WSID 50th New Clevis & Arm

W50-63112, W50-63111, W50-63100

Publication Date: March 2016

In conjunction with the WorldSID ISO Task Group, Humanetics has designed an updated clevis with larger holes and plunger ball for the WorldSID 50th Side Impact ATD.

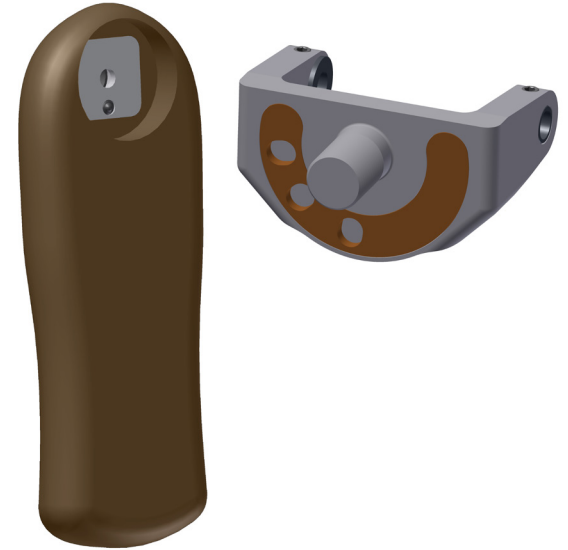
Users of the current WorldSID 50th ATD have noted that arm positioning can be difficult because it can be hard to feel the intermittent click stops that set the arm into one of several positions. In addition, the arm would sometimes move from suit tension after setup.

Under the direction of the Task Group, Humanetics beefed up the design of the clevis, using larger plunger ball holes that seat the arm into position. The number of holes was decreased and limited to three per side to eliminate possible handling issues such as mounting the clevis upside down, and positioning the arms incorrectly during certification testing. These new click stops improve the set-up performance as the arm position is better defined. This redesign also necessitated the creation of a right and left side clevis, thus making the current universal component obsolete.

The plunger ball in the arm was also made more robust by increasing its size to match the new

clevis click stops.

The new clevis and arm will be worked into normal ATD production, but will also be sold individually for those interested in updating their dummies. Old arms are not compatible with the new clevis design and must be replaced with the new arm to assemble correctly.
